**Trinity River Channel Rehabilitation Site:
Bucktail (River Mile 105.45-107.0)
Draft Environmental Assessment/Initial Study
DOI-BLM-CA-N060-2015-0057-EA and TR-EA0215**

November 2015

**Comments and Responses on the
Draft 2013 Bucktail and Lower Junction City EA/IS**

Figure 19.B.1. Upstream portion of the Bucktail Rehabilitation Site design as described in the Draft EA/IS.

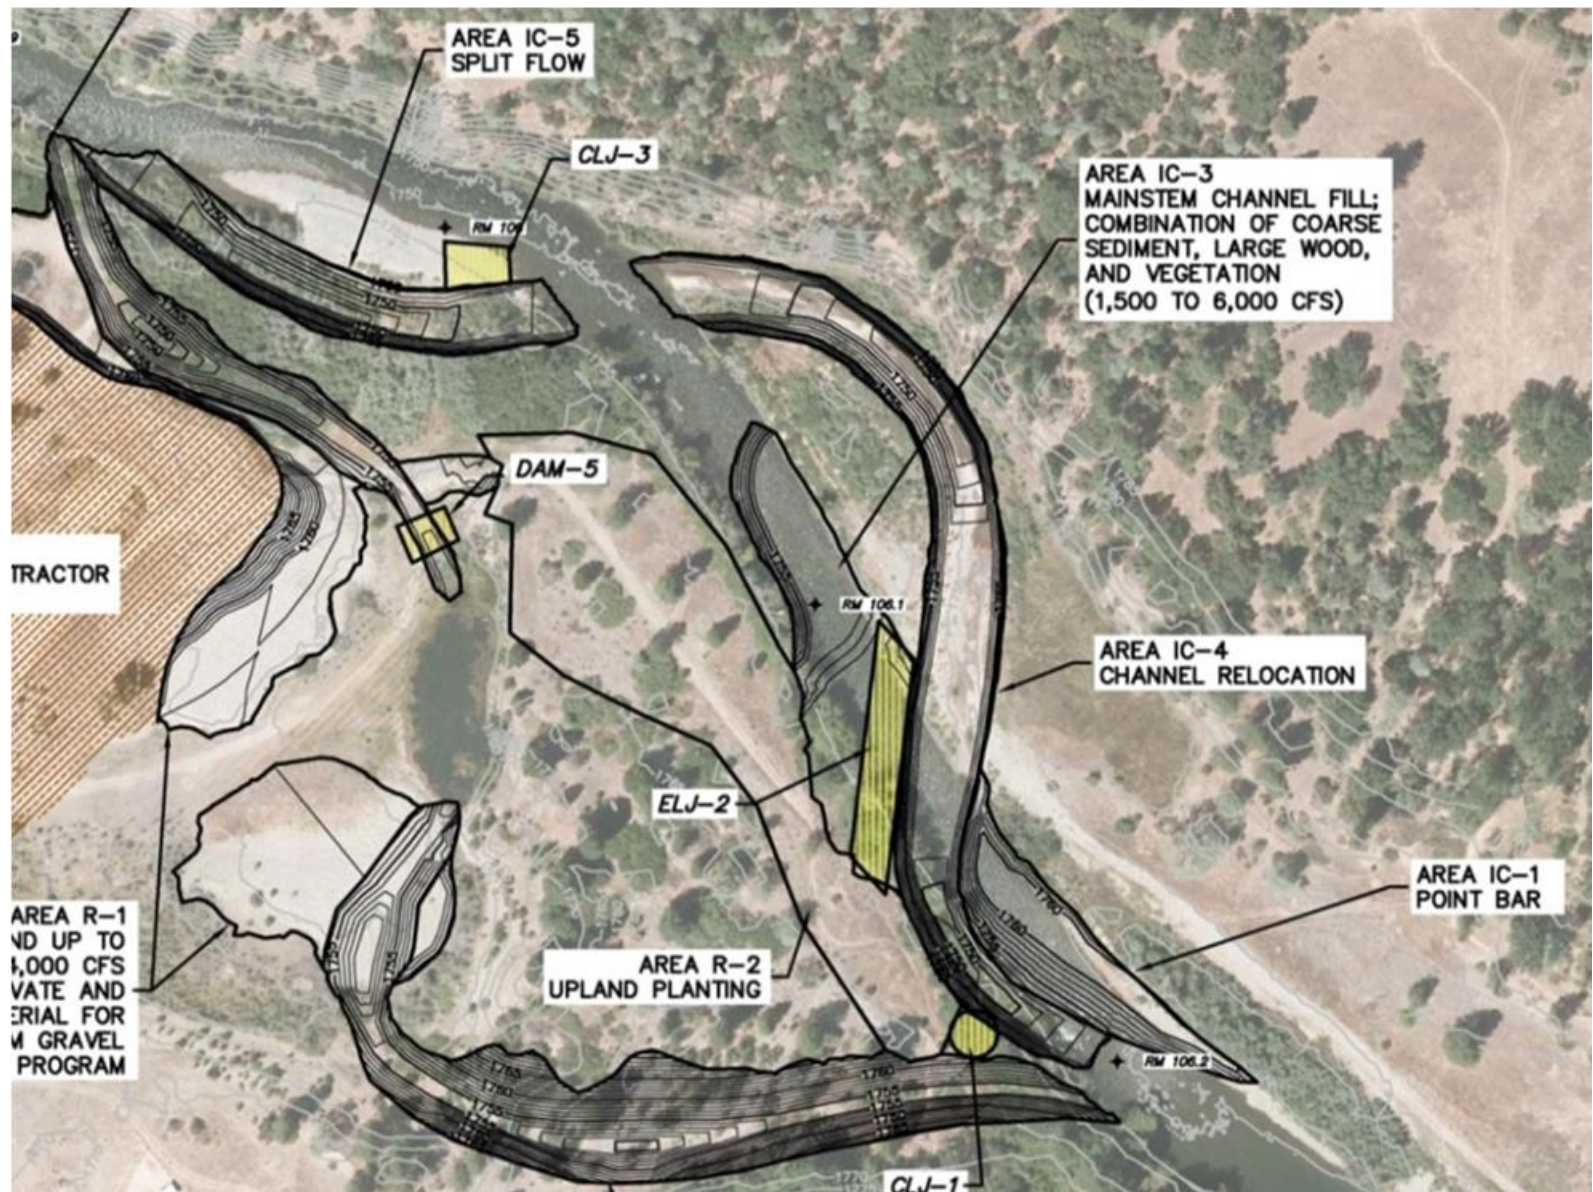
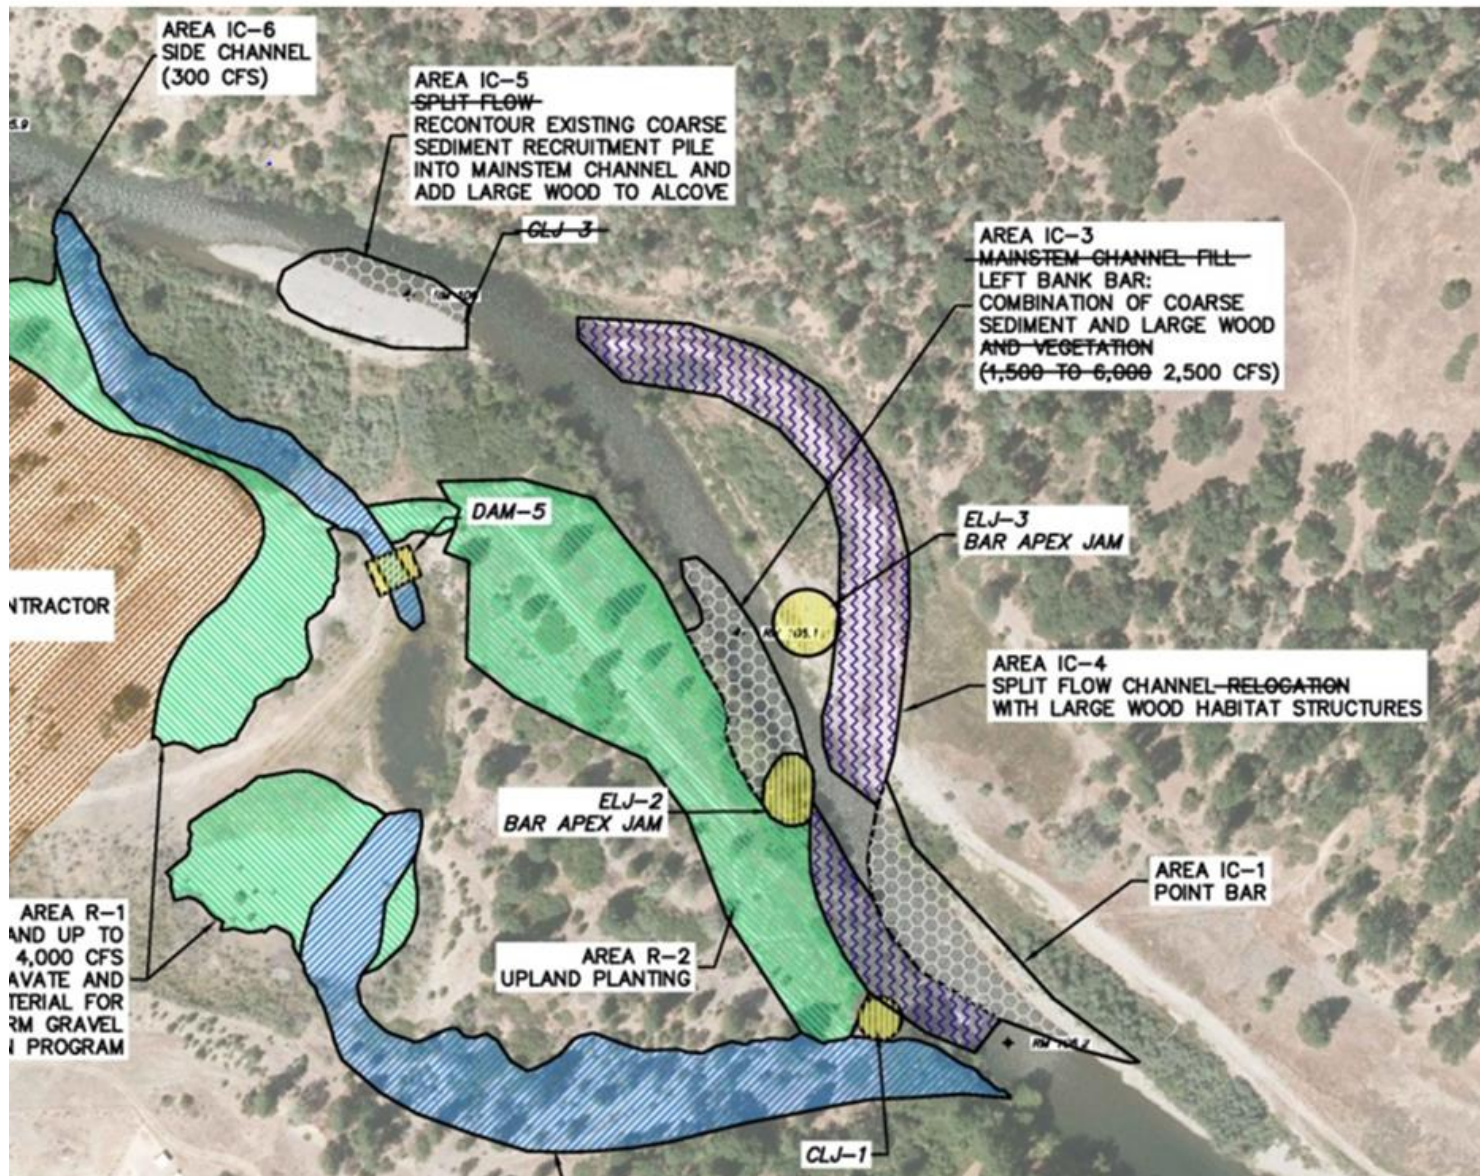
Comment 19.B – Bucktail design does not incorporate TRGA and public input.

The commenter notes that they have disagreed with the split flow and mechanical re-routing of the river. This is depicted at IC-4 in Figure 4 of the Draft EA/IS, and is shown in Figure 19.B.1 below.

The Bucktail design presented in Figure 19.B.1 (and in the Draft EA/IS) was the result of efforts to maximize juvenile salmonid habitat both immediately post-construction and into the future. Other factors leading to the design presented in Figure 19.B.1 included geomorphic and riparian design objectives. However, to achieve a successful relocation of the mainstem channel and achieve desired short and long term habitat benefits, it was determined that a large engineered log and rock structure, spanning the entire mainstem Trinity River channel, would be needed. This structure would have to be designed to survive maximum fisheries flow releases (approximately 11,800 cfs) to meet long-term goals. The size and stability of the proposed structure needed to relocate the river raised concerns that the channel would be unable to rework its bed and banks into the future.

Therefore, Project Areas IC-1, IC-3, IC-4, IC-5, and ELJ-2 design features are under revision to address both internal design group and public concerns.** The present concept, shown in Figure 19.B.2, includes a split channel without the engineered log jam (ELJ-2). This configuration and potentially other variations which are less extreme than that presented in the Draft EA/IS, will be evaluated to ensure that fish habitat, geomorphic, and riparian objectives are maximized, and that the risk of adverse long-term impacts (e.g., locking the channel in a fixed location) is minimized in the final Bucktail design recommended for implementation.

Figure 19.B.2. Current proposed revisions to the upper portion of the Bucktail channel rehabilitation site design.

Modeling output of juvenile chinook fry and pre-smolt habitat for the current proposed Bucktail design configuration (Figure 19.B.2) versus the Draft EA/IS design (Figure 19.B.1) are compared in Table 19.B.1.

The current habitat area compared to the Draft EA/IS Bucktail design shows a 200% to 400% increase in Chinook fry and pre-smolt habitat for a streamflow of 1,200 cfs (Table 19.B.1, the lowest habitat area value for Draft EA/IS conditions). The side channels shown in Figure 19.B.2 (shown with blue fill), account for more than 50% of the overall habitat gains shown in Table 19.B.1.

Figure 20.A. Example Bank Naturalization Project.

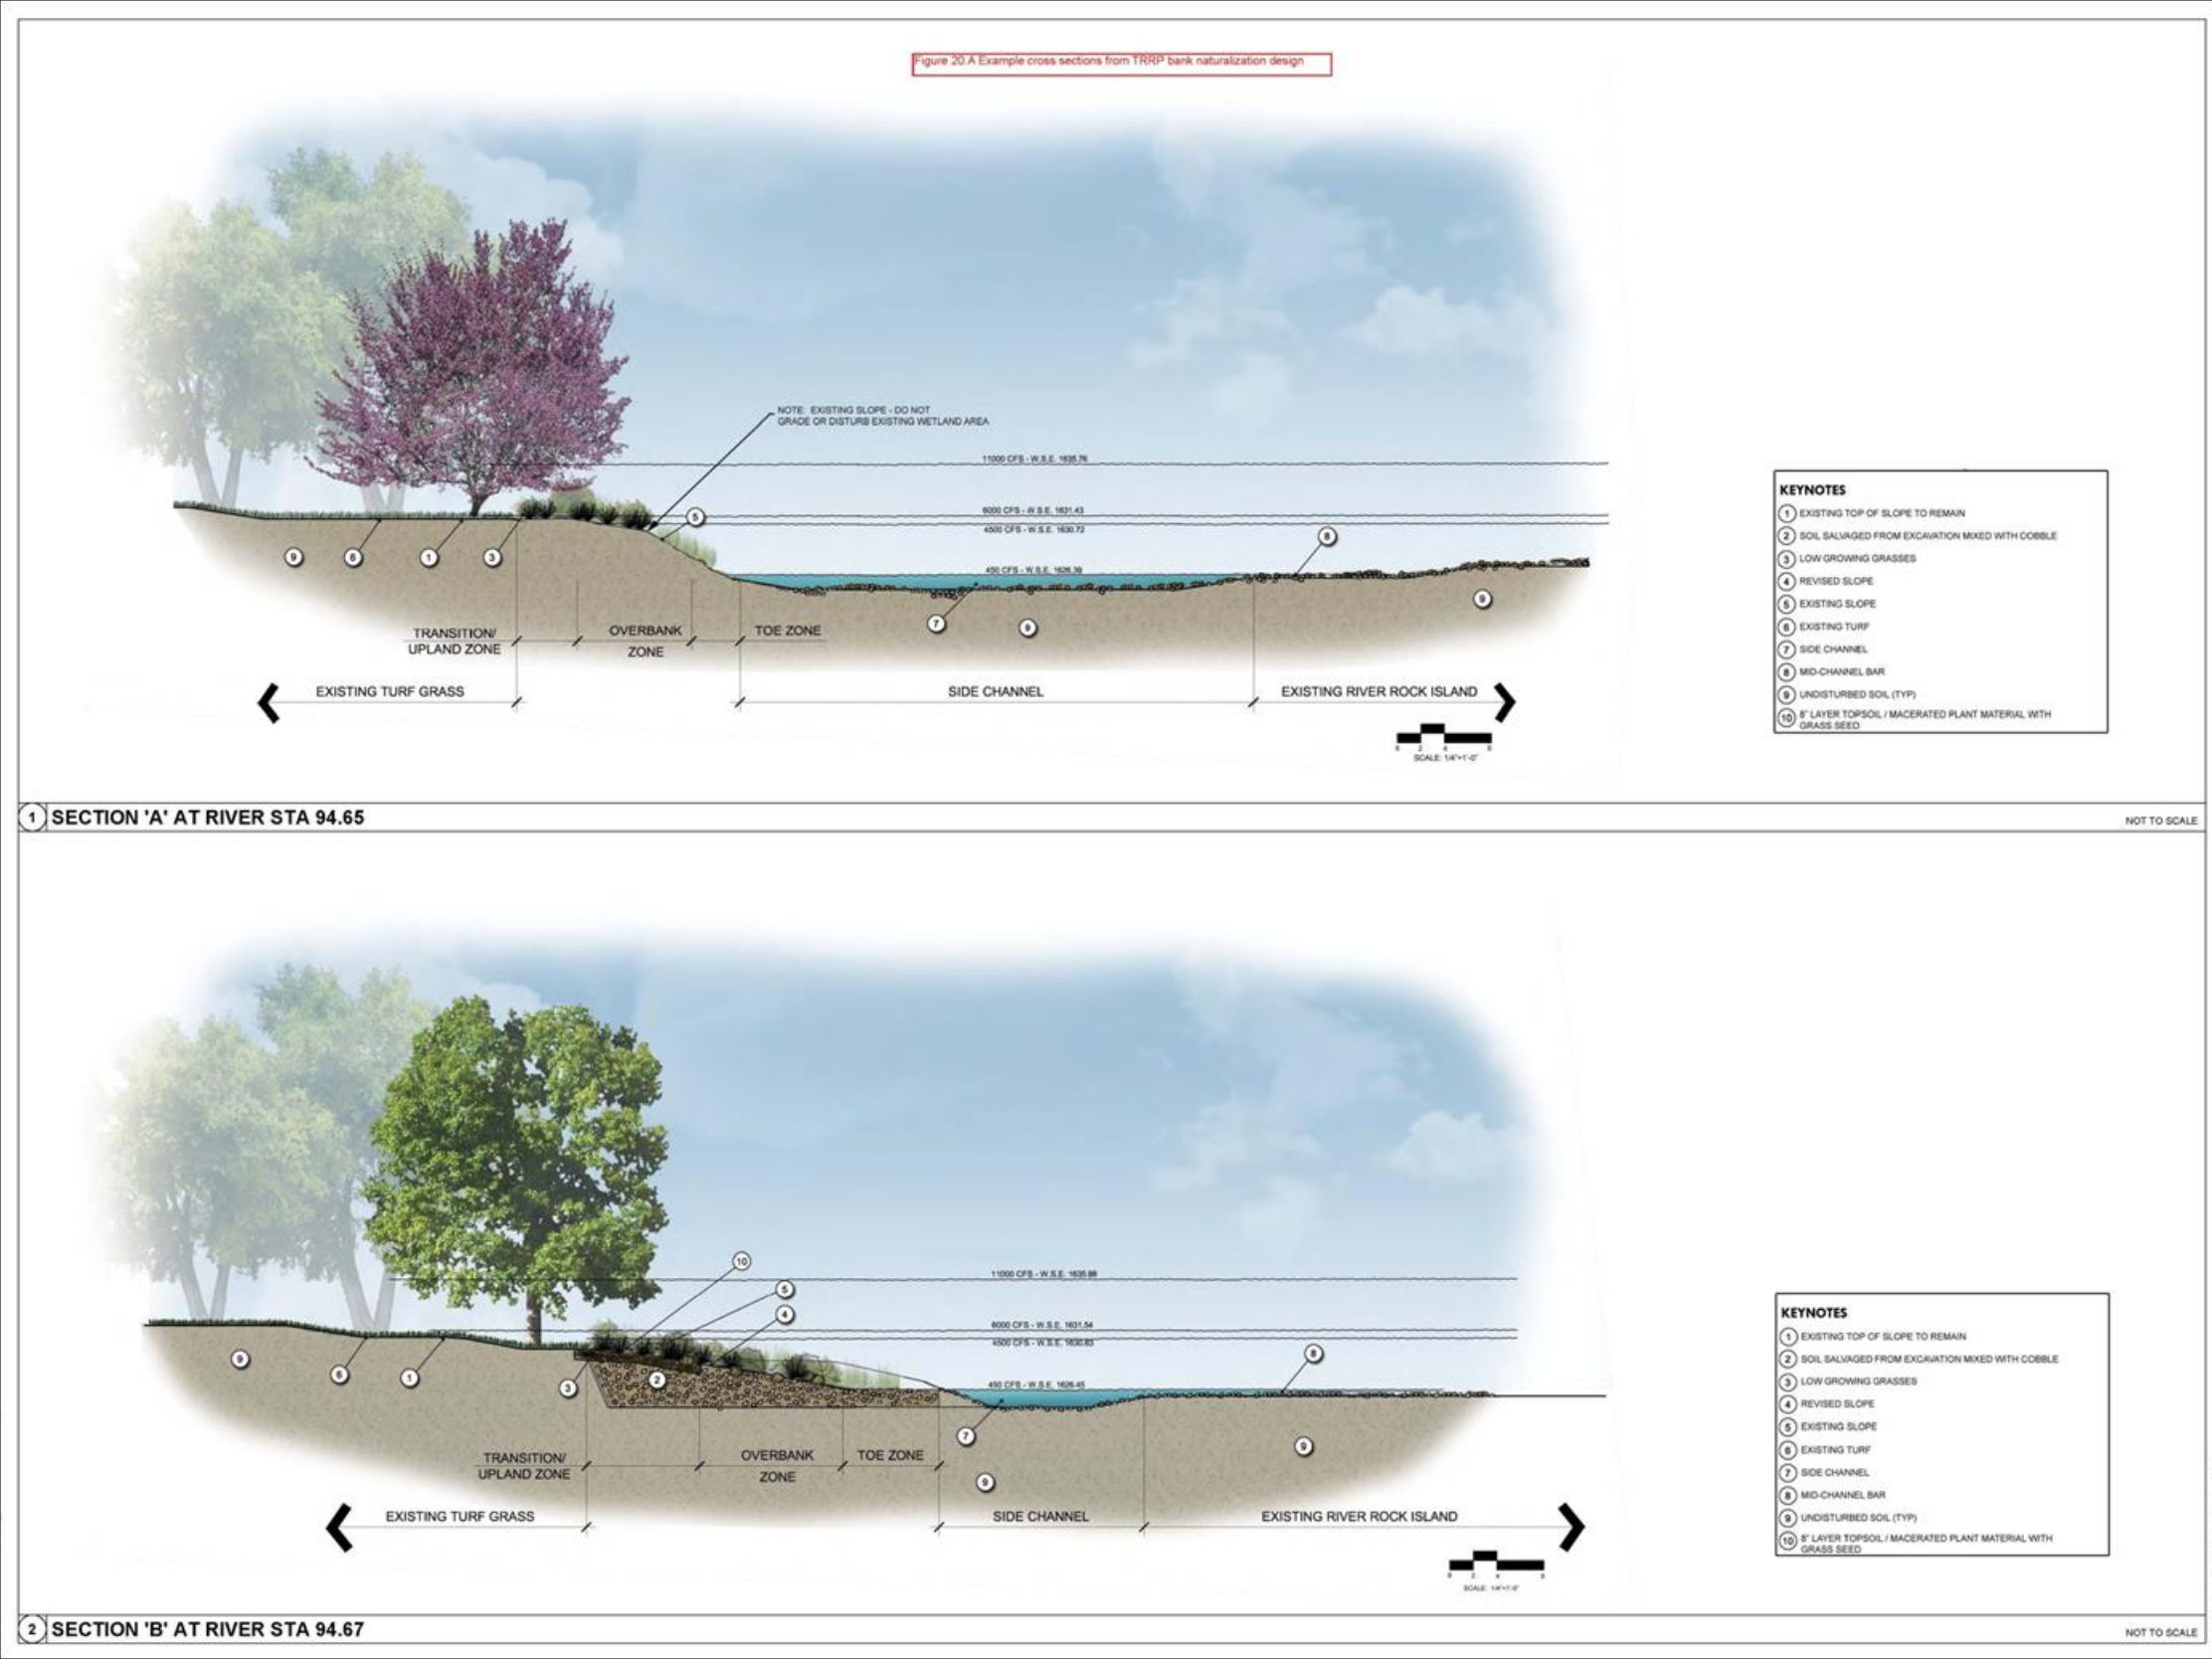
Comment 20.A – Tributaries have been ignored.

All project designs leveraged with TRRP funding such as a bank naturalization (biostabilization/revegetation) design provided to private landowners in 2013, are available upon request. Refer to Figure 20.A as an example.

Figure 20.D Total adult fall-Chinook escapement to Trinity River natural areas (River) above Willow Creek weir and TRH 2001-2012. (Draft figure from 2012 CDFW Trinity River basin salmon and steelhead monitoring project, 2012-2013 season report).

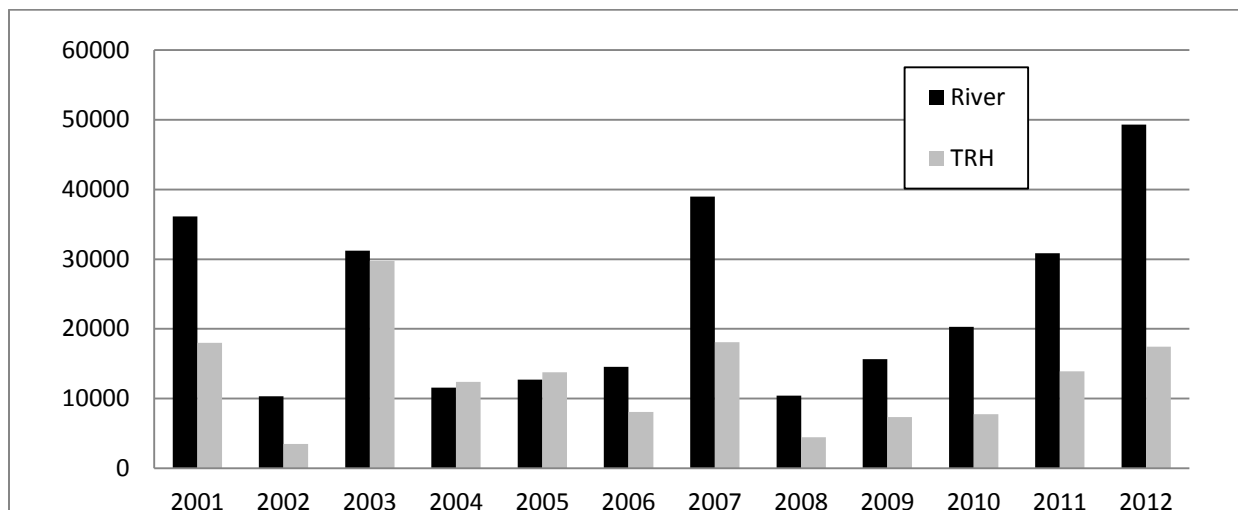
Comment 20.D – Dwindling adults result from unnatural gravel.

As for the number of spawning adults in the river, various factors, many of them outside of the Trinity Basin affect these numbers. The most recent California Department of Fish and Wildlife (CDFW) annual report for the Trinity River Basin Salmon and Steelhead monitoring project 2010-11 season (Sinnen et al. 2013; <http://odp.trrp.net/Data/Documents/Details.aspx?document=2120>) suggests that the natural contribution of fall run Chinook salmon upstream of Willow Creek has been increasing over the last 10 years, and that overall salmon and certainly steelhead numbers have also been trending positively. Figure 20.D below, produced from 2012 CDFW data, also supports this increasing trend in naturally produced Trinity River fall-Chinook salmon.
